**ZONING AMENDMENT
& SUBDIVISION STAFF REPORT****Date: May 21, 2015****APPLICANT NAME**

Alabama Baptist Children's Home Subdivision

APPLICATION NUMBER 13 DATE May 21, 2015
 APPLICANT Alabama Baptist Children's Home Subdivision
 REQUEST Subdivision, Rezoning from R-1 to B-1

SITE PLAN

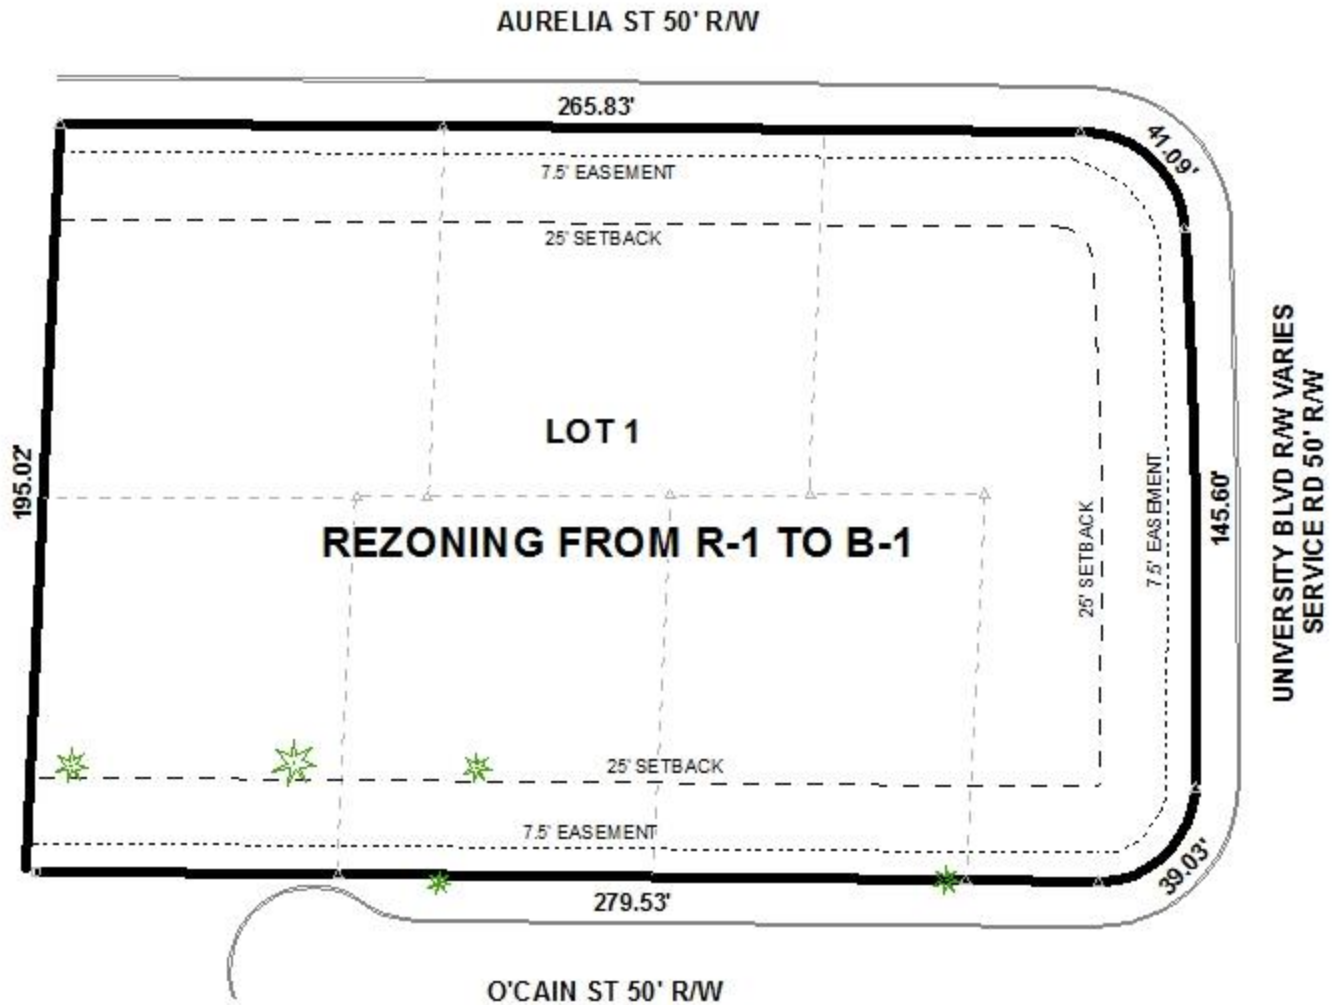
The preliminary plat submitted does provide the lot size in square feet and acres, and it should be noted that the proposed lot exceeds the minimum required lot size in Section V.D.2. of the

The site fronts onto Aurelia Street, University Boulevard Service Road, and O'Cain Street. Aurelia Street and O'Cain Street are both minor streets with curb and gutter, and should therefore have right-of-ways of 50'. The preliminary plat illustrates Aurelia Street and O'Cain Street with existing 50' right-of-ways, making no dedications necessary. University Boulevard is a major street and should therefore have a right-of-way of 100'. The preliminary plat illustrates University Boulevard Service Road as having a right-of-way of 50', which would indicate that perhaps there is sufficient right-of-way at this time; however, the preliminary plat should be revised to accurately reflect the right-of-way for University Boulevard.

The 25-foot minimum building setback is depicted for the proposed lot, and should be retained on the Final Plat, if approved.

The preliminary plat illustrates a 7.5' utility easement surrounding the property. A note should be placed on the Final Plat, if approved, stating that no permanent structures are to be erected within any easement.

The applicant's narrative states that there is an existing 7' high block wall along the West property line, however the preliminary plat illustrates a 0.6' high block wall. The preliminary plat should be revised to accurately illustrate the height of the wall.

- 1) illustration of the 25' minimum building setback line along all frontages;
- 2) retention of the lot size in square feet and acres;
- 3) revision of the Final Plat to illustrate University Boulevard has a compliant right-of-way of at least 100';

- 4) placement of a note on the Final Plat stating that no structures are allowed in any easement;
- 5) full compliance with Engineering comments: *(The following comments should be addressed prior to submitting the FINAL PLAT for acceptance and signature by the City Engineer: A. Add a vicinity map. B. Provide and label the POB. C. Provide all of the required information on the SUBDIVISION PLAT (i.e. signature blocks, signatures, certification statements, written legal description, required notes, legend, scale, bearings and distances) that is required by the current Alabama State Board of Licensure for Professional Engineers and Land Surveyors. D. Add a note to the SUBDIVISION PLAT stating that a Land Disturbance permit will be required for any land disturbing activity in*
